SAN FRANCISCO PLANNING DEPARTMENT

Permit to Alter Case Report

Filing Date: November 21, 2012
Case No.: **2013.0167H**
Project Address: **135 Powell Street**
Category: Category II (Significant)
Zoning: C-3-R (Downtown-Retail)
80-130-F Height and Bulk District
Block/Lot: 0326/003
Applicant: Tom Lewis,
Tom Lewis Restoration & Consulting, INC.
768 Brannan Street
San Francisco, CA 94103
Staff Contact Lily Yegazu - (415) 575-9706
lily.yegazu@sfgov.org
Reviewed By Tim Frye - (415) 558-6625
tim.frye@sfgov.org

The proposed project is to replace the top course of the damaged terra cotta at the cornice line and just below the parapet wall with glass fiber reinforced concrete (GFRC). The new GFRC is proposed to match in color, texture, and profile the terra cotta that would be removed. The structural steel supporting the subject terra cotta will also be replaced due to its corrosive damage as a result of water penetration.

SECTION - C

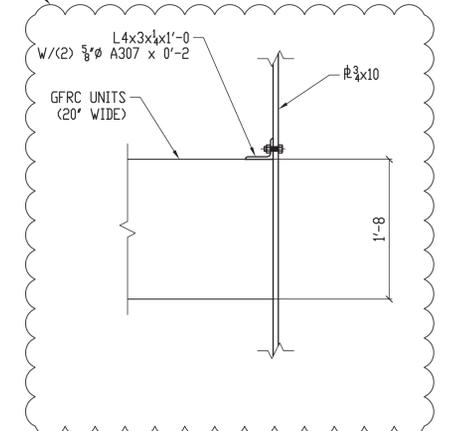
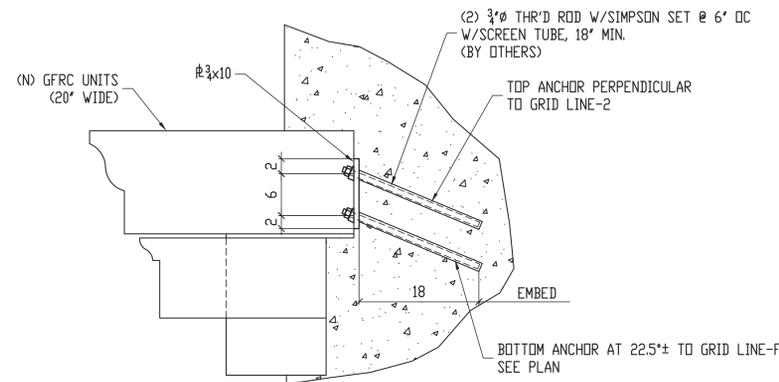
APPROVER:
a.) PLEASE VERIFY ANGLE AT ONE SIDE OF GFRC UNITS REF 3/S2
b.) PLEASE FURNISH CONN. FOR ANGLE TO GFRC UNITS

SHEET TITLE
PARTIAL PLAN AND
STRUCTURAL DETAILS

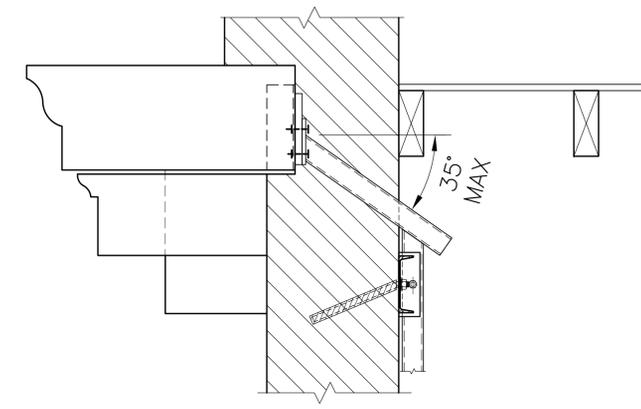
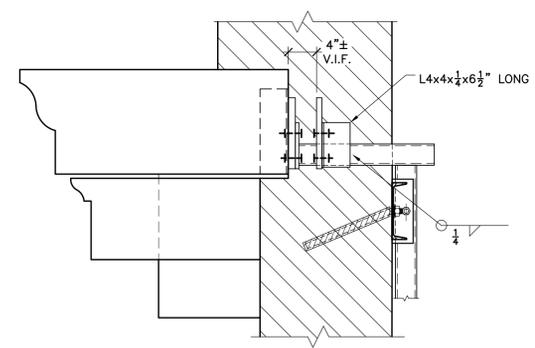
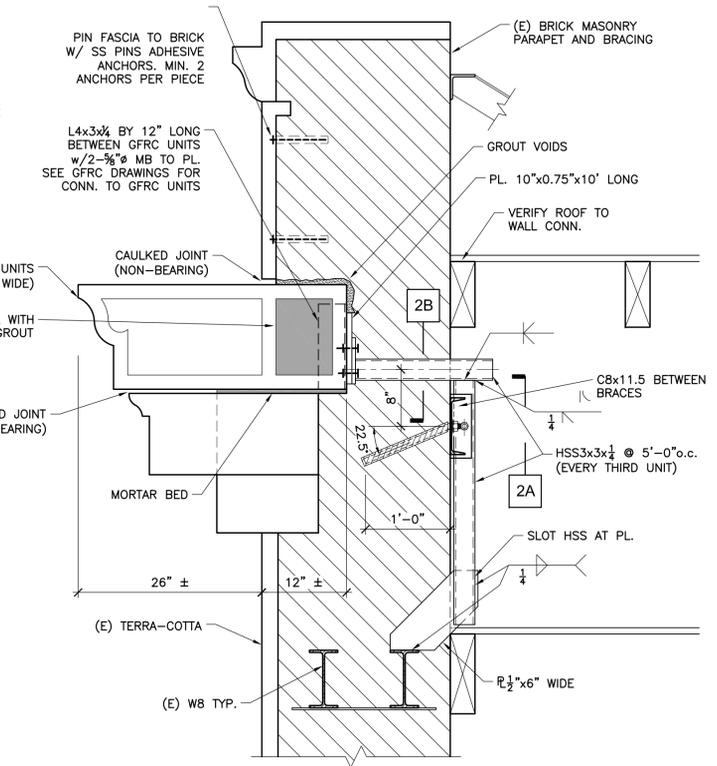
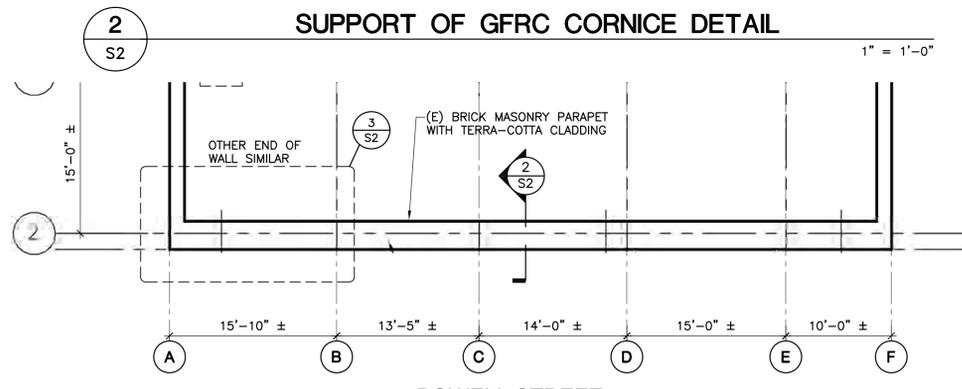
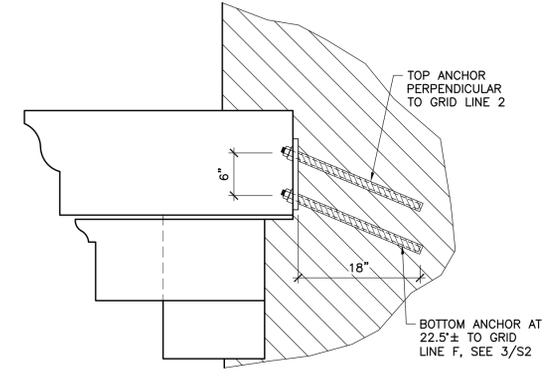
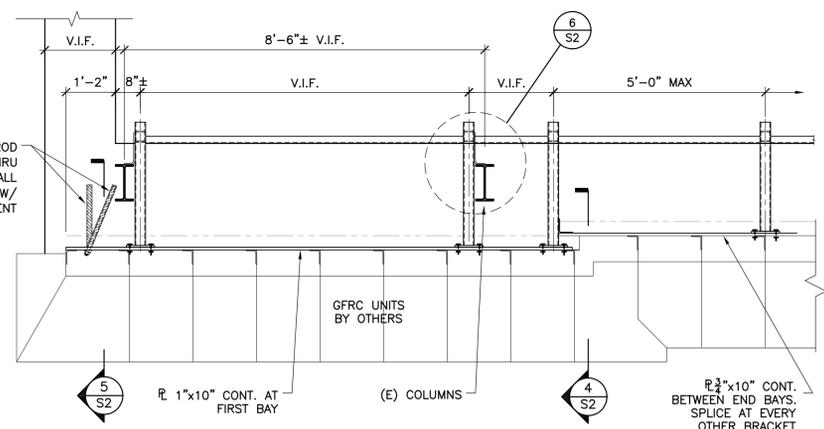
It should be noted that the plans submitted have a discrepancy in the profile of the existing and replacement units. Specifically the profiles shown on the detail drawings on Sheets A-1, S2, and E21 do not accurately display the profile of the units whereas the hand drawings by Architectural Facades show the true profile, matching the photographs of both the existing terra cotta units and the replacement GFRC units. In addition, as the replacement units will be made from molds taken from the existing terra cotta, the accurate duplication of the units will be ensured. However, to ensure consistency in the plans, the Project Sponsor has been notified that revised drawings with details of accurate profiles would need to be submitted prior to issuance of a building permit.

3. The Project Sponsor shall submit revised plans with details that accurately match the profiles of the existing terra cotta units and replacement GFRC units prior to issuance of a building permit.

3. The Project Sponsor shall submit revised plans with details that accurately match the profiles of the existing terra cotta units and replacement GFRC units prior to issuance of a building permit.
